# Service Bulletin

Bulletin No.: PIC5933

**Subject:** Rear Fascia Not Flush To Rear Quarter Panel

**Models:** 2013 - 2014 Chevrolet Malibu

3649283

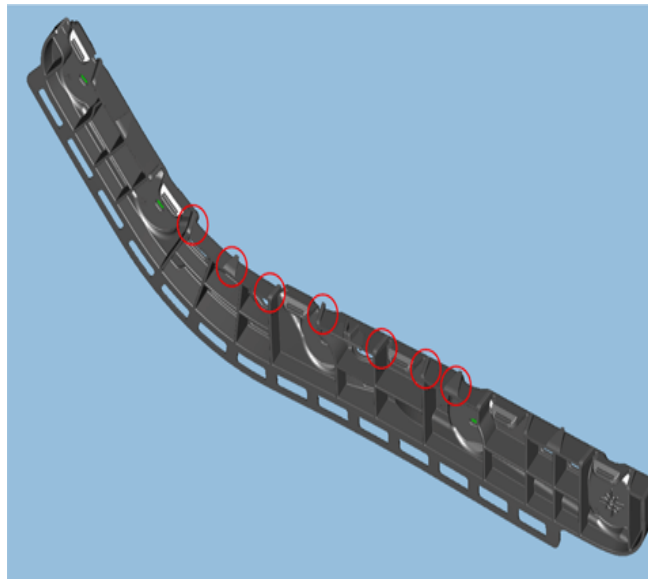
A customer may indicate the rear fascia does not fit flush with rear quarter panel on either side of the vehicle. Build tolerance may cause a condition in which the distance between the rear fascia bracket and the quarter panel is too tight. This may not allow the rear bumper fascia to seat into the bracket.

Using the image below as a guide, remove the seven (7) indicated standoffs from the Rear Bumper Fascia Outer Guide on the effected side. Once the standoffs have been removed, reinstall the fascia and confirm proper fit.

Remove the rear fascia following the "Rear Bumper Fascia Replacement" procedure in Service Information.
